CITY OF MERCER ISLAND

Re: Review Letter for CAO18-003 - Critical areas Determination
Regarding: possible piped watercourse and the type IV wetland located at 8114 West Mercer Way Mercer Island, WA 98040; Parcel ID: 33585-00974

The City has completed the first round of review for CAO18-003 Critical Areas Determination. Following review of the application, City staff has determined that additional information is necessary to ensure compliance with the Mercer Island City Code (MICC) and to continue processing of the application. Required information and corrections are detailed below.

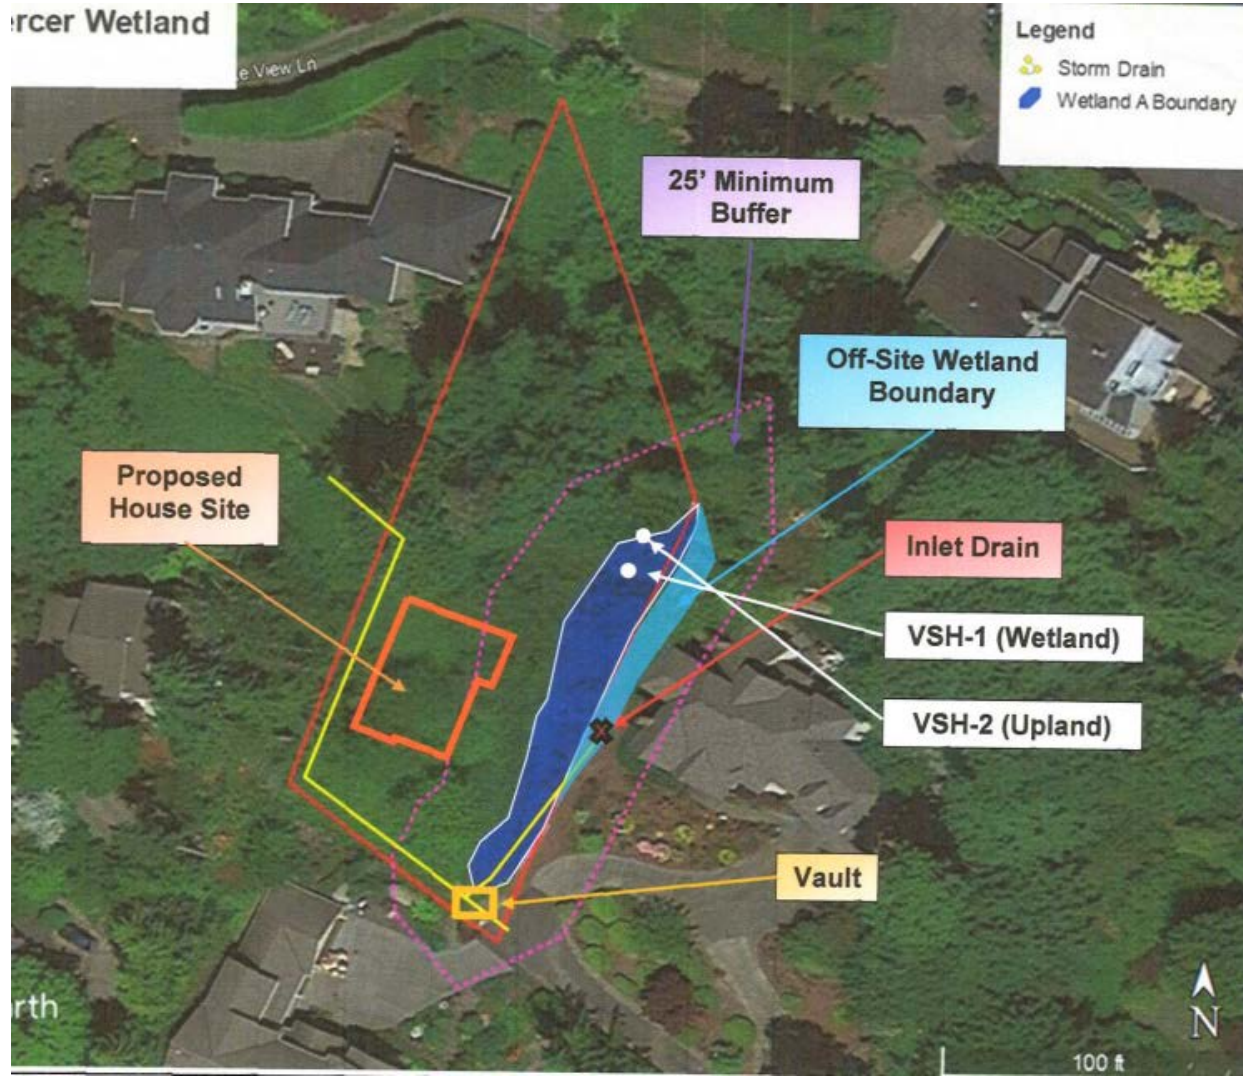
Lauren, I wanted to reach out regarding the proposal CAO13-03. I am the owner of 8122 W. Mercer Way, the property directly below the proposed changes to the minimum buffer. I have some significant concerns regarding the proposal and the vague nature of both the proposal and the impact. If they are proposing a reduction of the minimum buffer in some areas, where is the impact analysis to overall erosion and potential damage down-hill to our property? Also, what is the proposed plan to compensate for the reduction of the wetlands in the proposal?

In addition, we consulted with another consultant who informed us that the outline below is missing another wetland on the property. I would like to request an additional survey to ensure that all wetland impacts and potential damage to both the environment and to our property are understood, taken into account and mitigation plans developed.
